Access Compliance Report

Public Rights-of-Way

Intersection ID: 17261	Main Street: LYNNWOOD_DR	Cross Street: WESTFIELD_RD	Location: NE
ADA ID: 8349A8E84719	Ramp Type: PerpDiag	Initial Pass/Fail: Pass	Overall Compliance: No
			Severity Score: 17.75

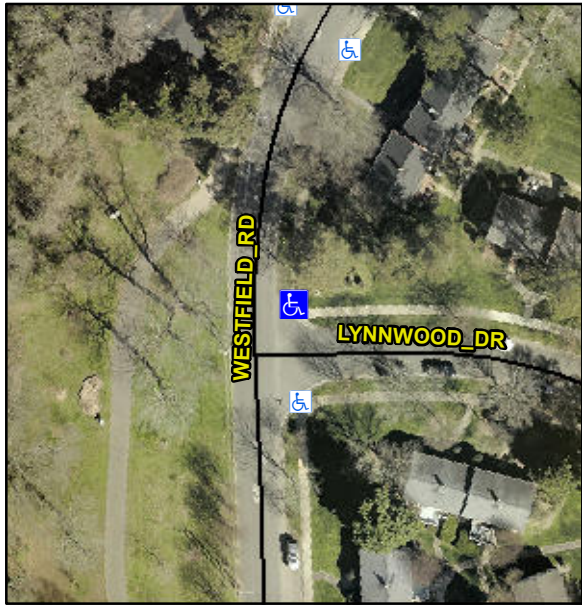
Codes/Mitigation Info/Possible Solution			Field Measurements/Component Compliance					
	Possible Solutions:		Compliance	Description	Data	Compliance	Description	Data
	Remove & Replace Curb Ramp With Two New Directional Ramps or Equivalent. Remove & Replace Gutter.		N/A	Ramp Length (in)	53.0	Yes	Ramp Slope (%)	5.1
			Yes	Ramp Width (in)	80.0	No	Ramp XSlope (%)	3.2
			N/A	Flare Type LT	None	N/A	Flare Type RT	N/A
			N/A	Flare Slope LT (%)	N/A	N/A	Flare Slope RT (%)	N/A
			N/A	Flare Traversable LT?	N/A	N/A	Flare Traversable RT?	N/A
			No	Landing Length (in)	N/A	Yes	DWS Provided?	Yes
			No	Landing Width (in)	N/A	Yes	DWS Contrast?	Yes
			No	Landing Slope (%)	N/A	Yes	DWS Length (in)	24.0
			No	Landing X Slope (%)	N/A	No	DWS Full Width?	No
			N/A	Landing Curb? (Y/N)	No	No	DWS Offset (in)	5.5
			N/A	Shared Landing?	N/A			
			Yes	Gutter Ponding?	No	No	Gutter Slope (%)	8.7
			Yes	Gutter Lip Ht (in)	0.0	Yes	Gutter X Slope (%)	1.0
